REVISION- 6/09/22 CENTER ENTRY/ DOOR ON REAR LANAI

Reviewed for Code Compliance Dwayne Ausley

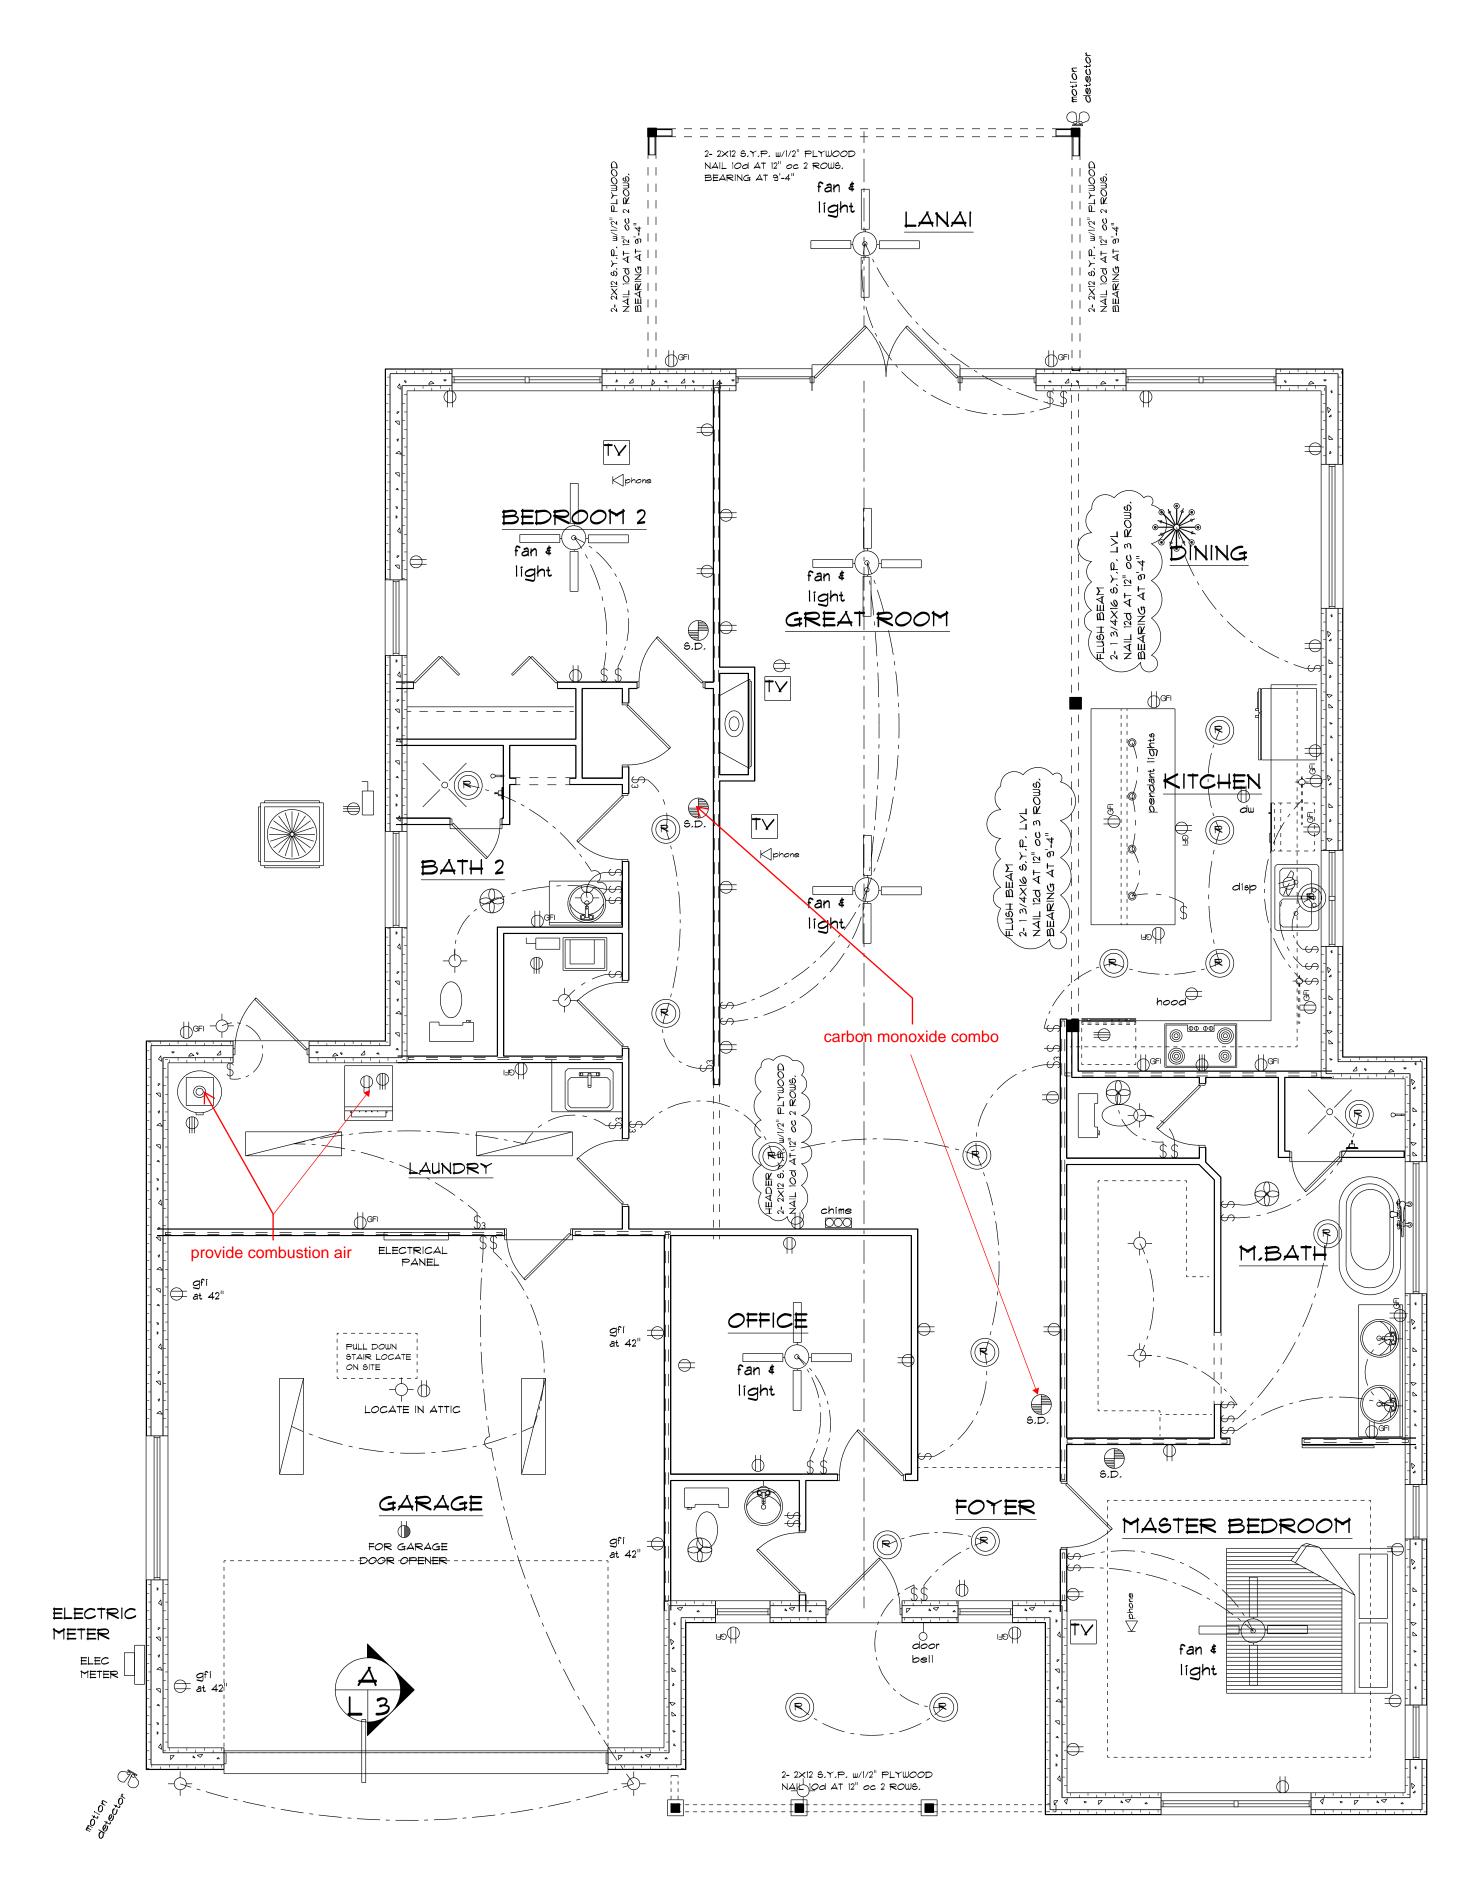
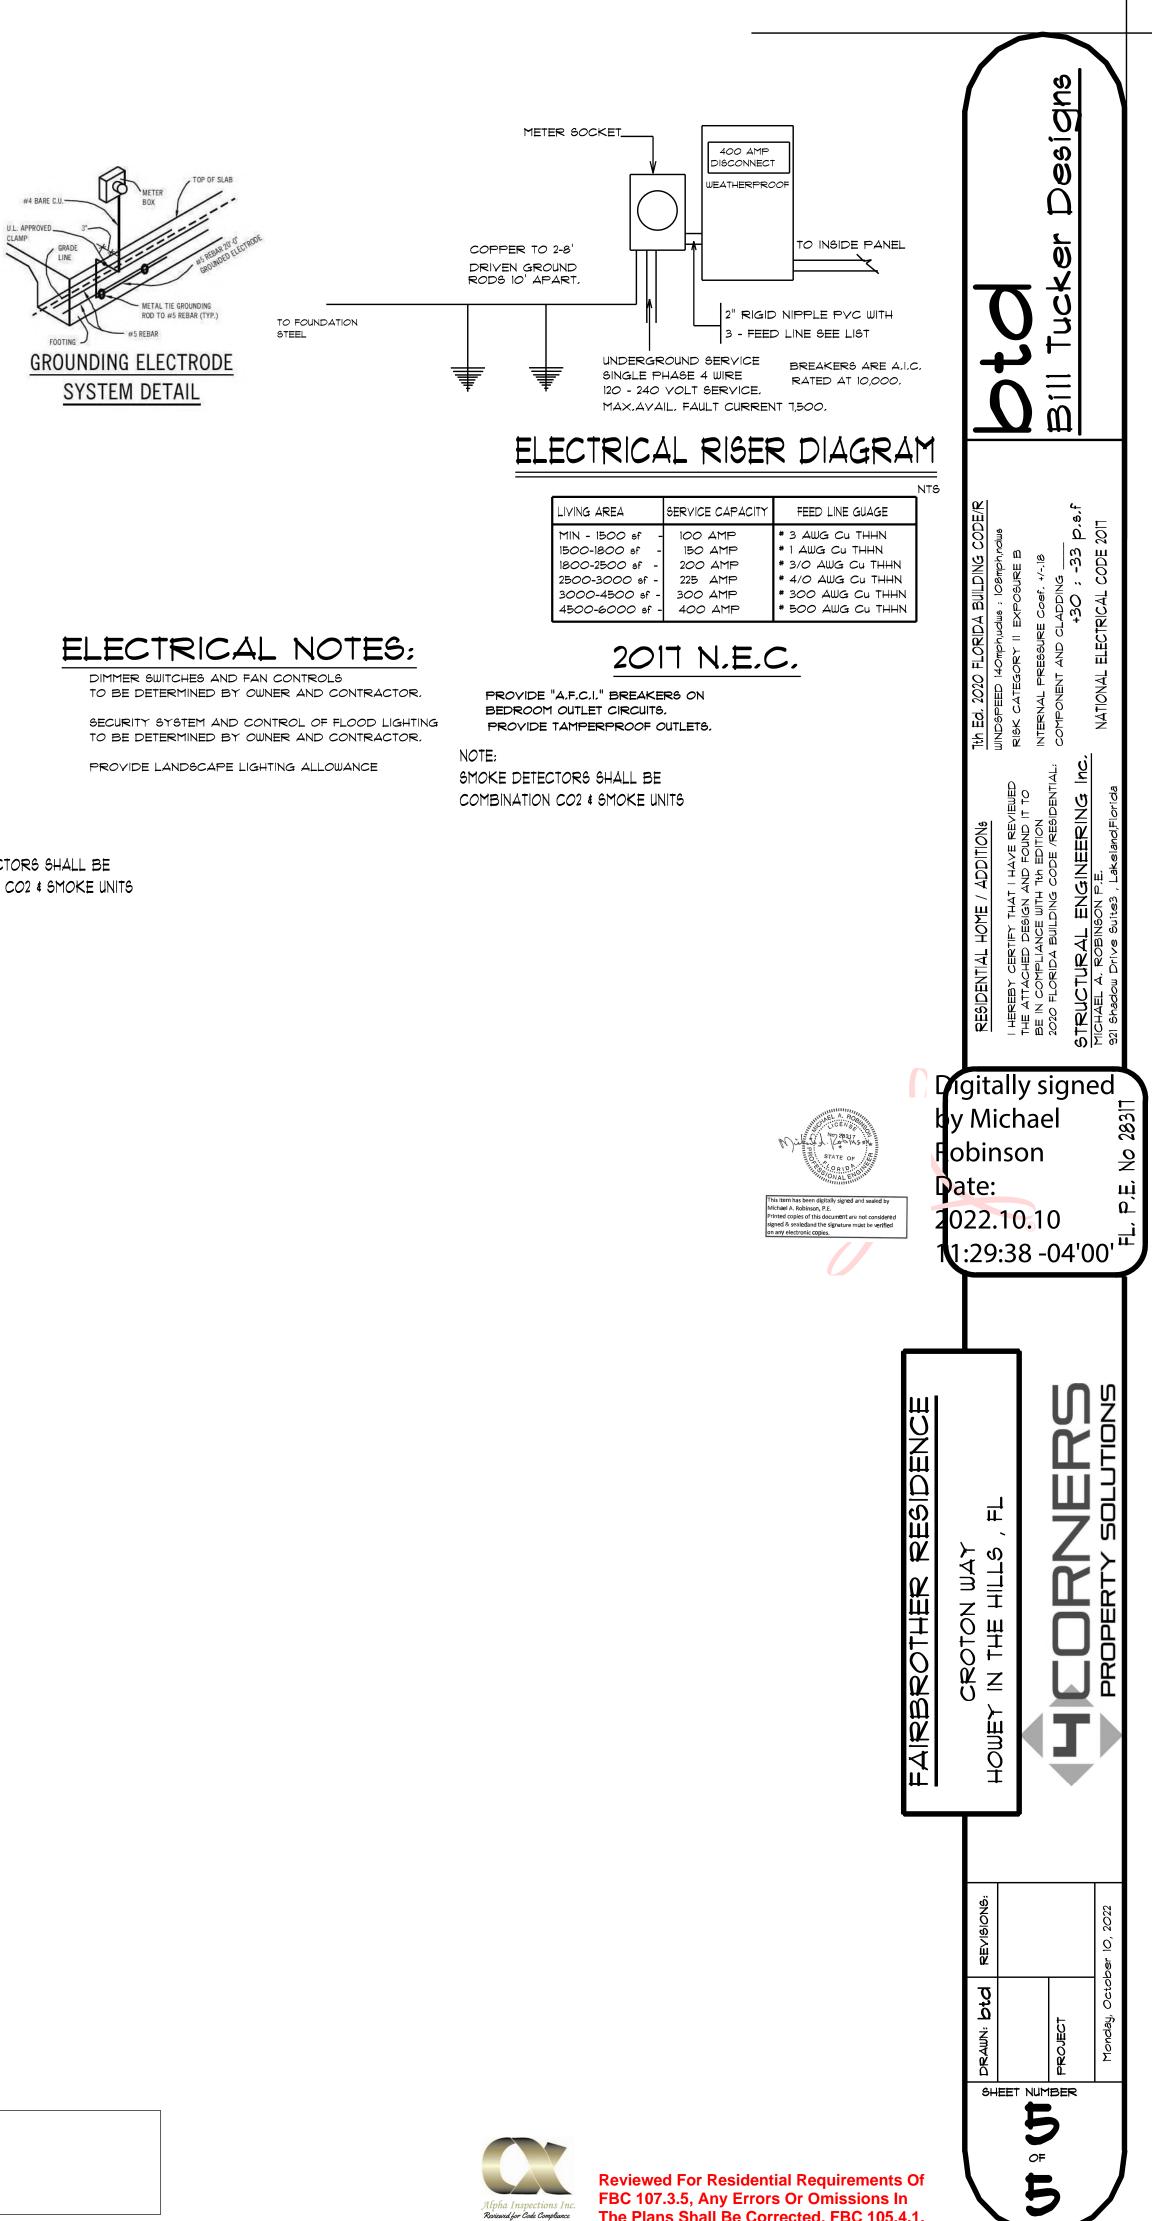
The Electrical Plan Is Not Part Of This Review. All Electric Shall Be In Accordance With NEC 2017.
